# Smithfield - RH 'FRENCH COUNTRY' ELEVATION

156 DC - 452 Duncan Creek Rd., Lillington, NC 27546

9-28-24 - Redlines - JJ

12-12-24 - Change to Side Load garage - JJ

**CRAWL FOUNDATION PLAN 'FRENCH COUNTRY'**  
SCALE: 1/8"=1'-0" ON 11x17, 1/4"=1'-0" ON 22x34

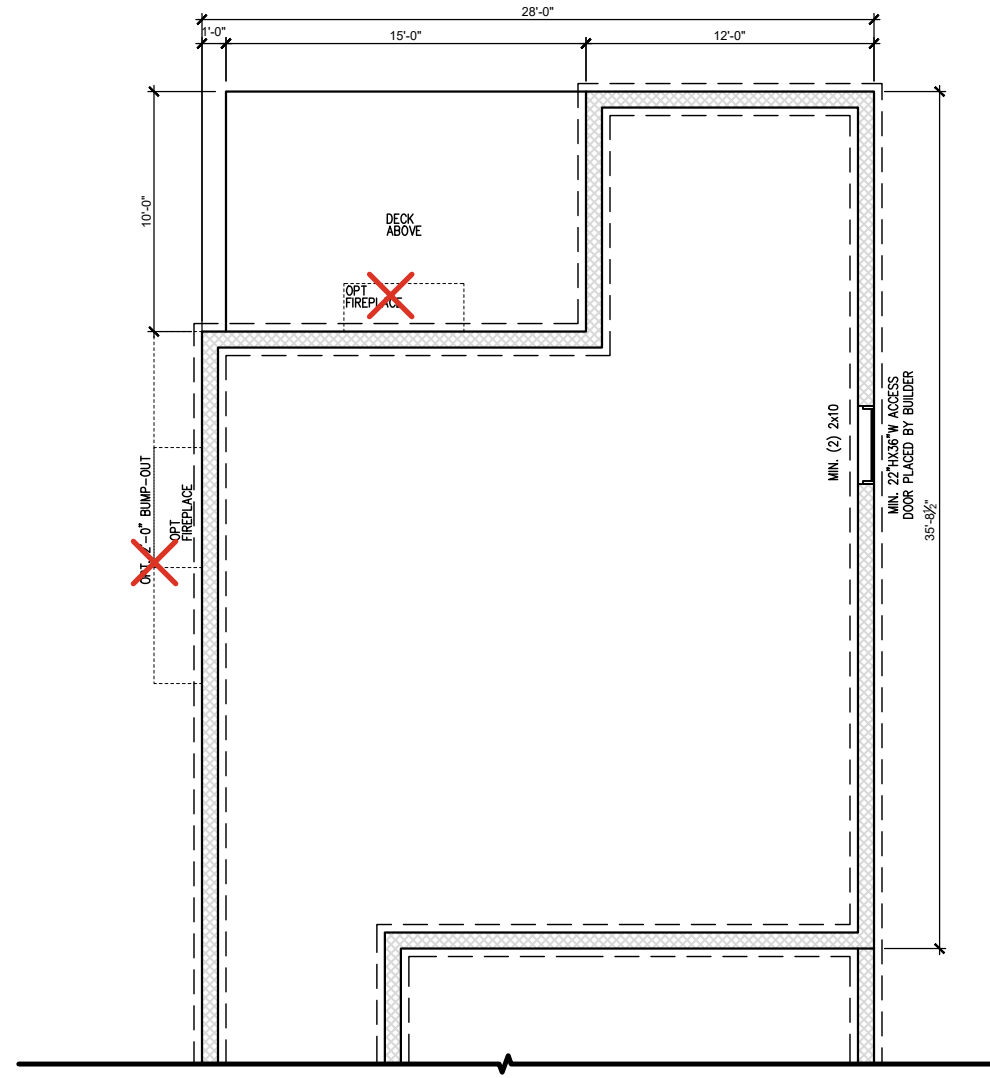
See Sheet 1.2.1b  
for altered foudation

See Sheet 1.2.2b for  
side load garage  
foundation

**SECOND FLOOR PLAN 'FRENCH COUNTRY'**  
SCALE: 1/8"=1'-0" ON 11x17, 1/4"=1'-0" ON 22x34

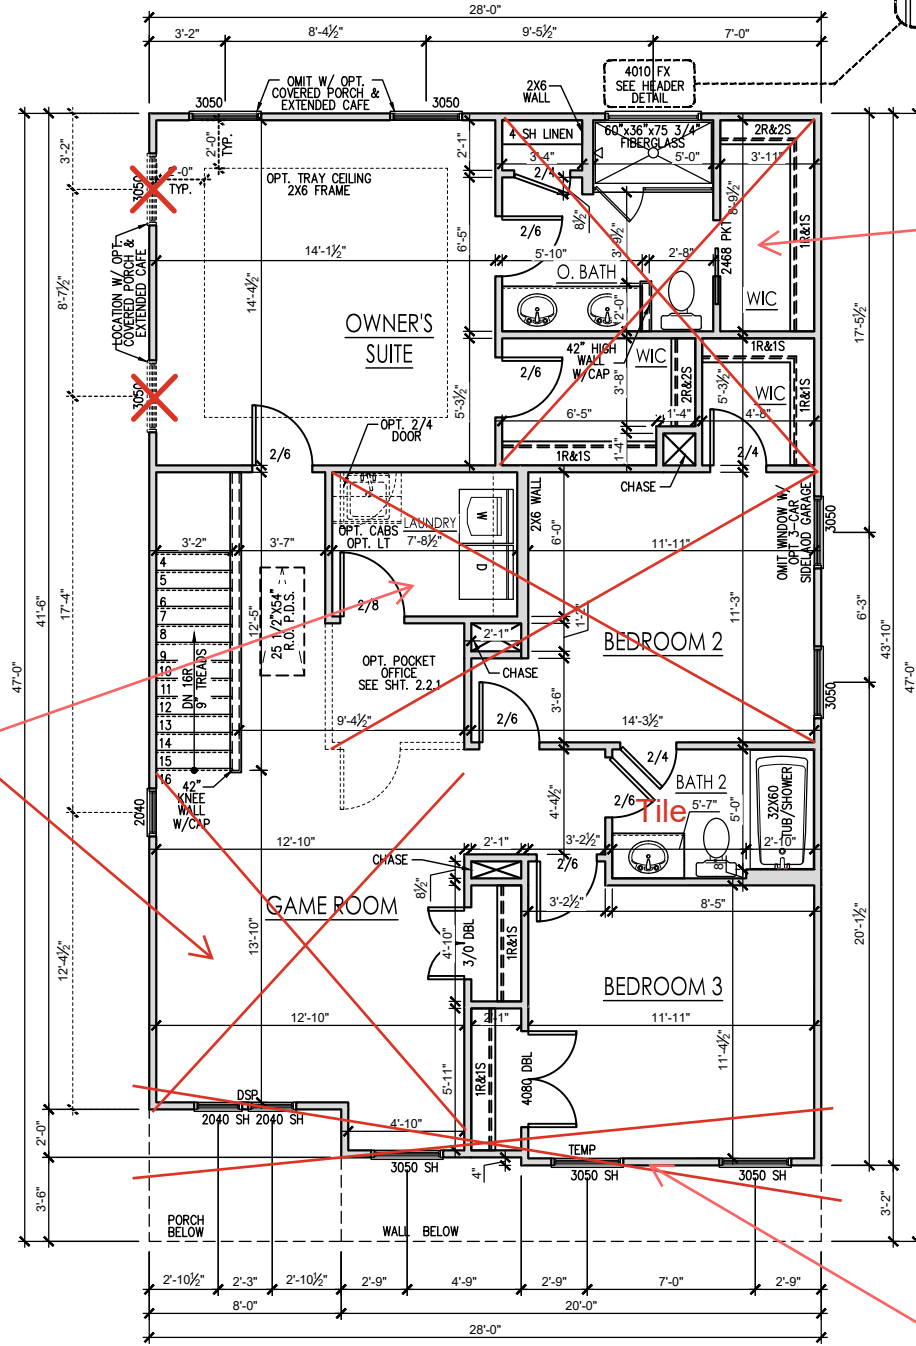
2.2.1b for Owner's Bath

2.2.1b for laundry, pocket office bedroom 2 and bedroom 4

See Sheet 2.7b for window locations

"FRENCH COUNTRY" ROOF PLAN  
SCALE: 1/4" = 1'-0" ON 22x34, 1/8" = 1'-0" ON 11x17

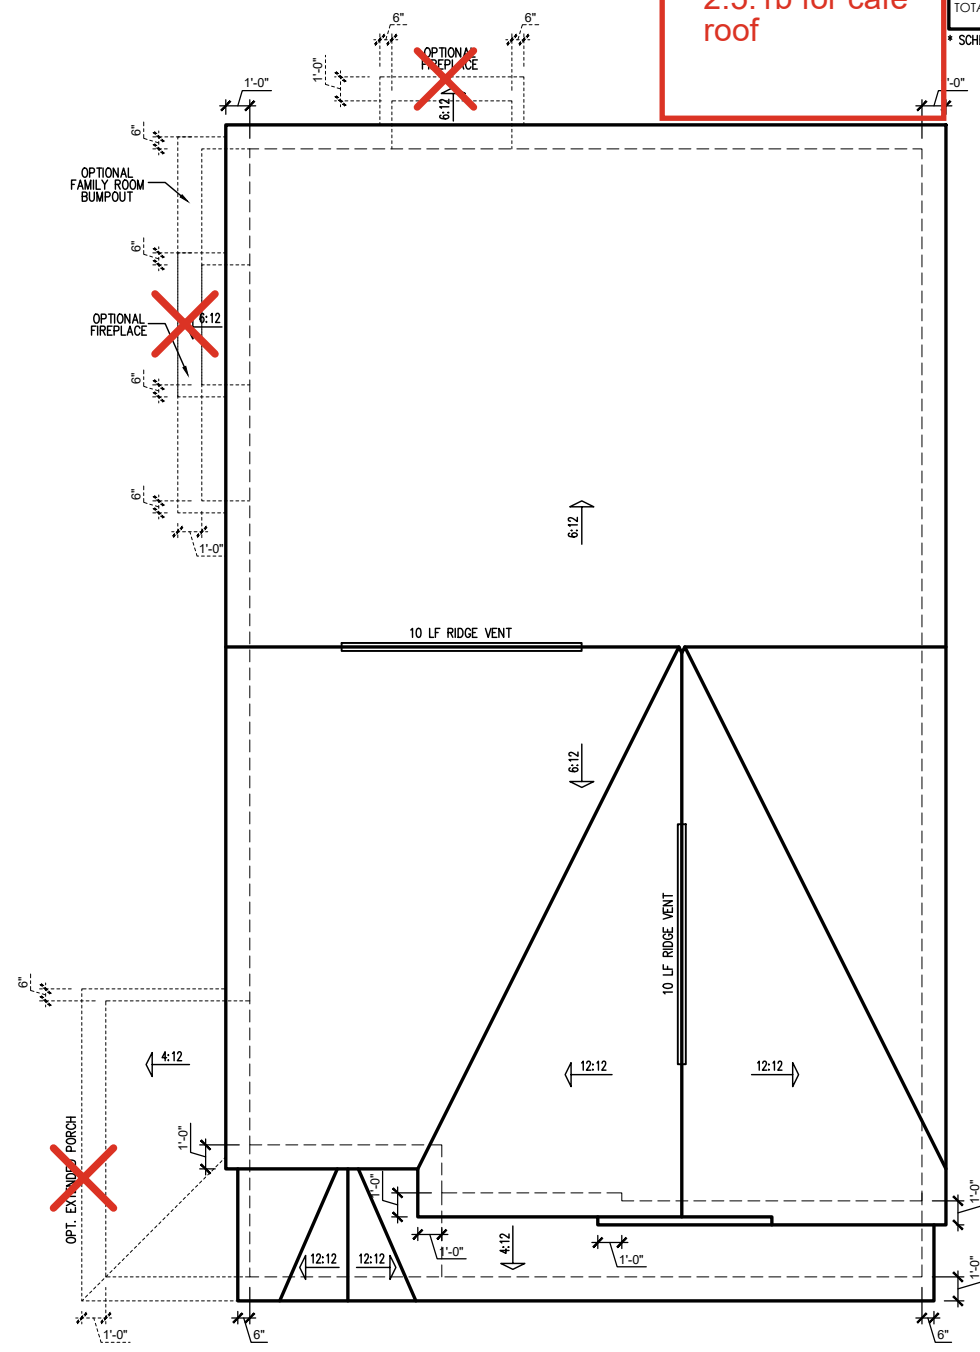
2.5.1b for cafe roof
